Tech Bulletin:

Aura Pro Cervélo Custom Edition aerobars fitted to some 2013 Cervélo bicycles: issue with clamp fixing bolts

Figure 2: affected bolt on Aura PRO bar in Cervélo version

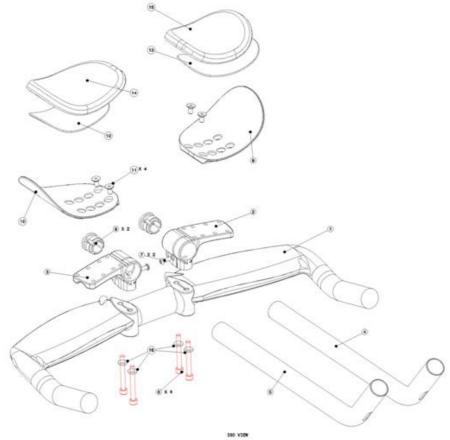
The bolts fixing the clamps may be too short for the increased overhang of the wider clamps and may not provide sufficient engagement to secure the clamp.

Bolts are shown in red, position 6, in figure 2 below.

Affected bolts have been delivered in M5 x 35 mm DIN912 specification. New bolts are specified as M5 x 45 mm DIN912, in order to guarantee the highest safety standards available.

We want to stress that this issue affects only bars delivered with a Cervélo bike that have the wider clamps shown in figure 1. If you are an owner of such a bike, please disassemble the affected bolts (as per Figure 2, position 6) and measure their length. If the bolts are less than 45 mm long (affected, wrong bolts are 35 mm), they must be replaced bolts with new, longer (45 mm) bolts.

There is no need to return the bike to your dealer or distributor to solve this issue. Simply replace the wrong bolts with new, longer bolts that 3T or our local distributor will send you, free of charge, to ensure you can ride safely with the minimum of downtime.

Please note that the maximum torque of these bolts is 5 Nm. Always use a calibrated torque wrench. If you are not confident you can successfully install the bolts, please have a qualified cycle mechanic carry this out.
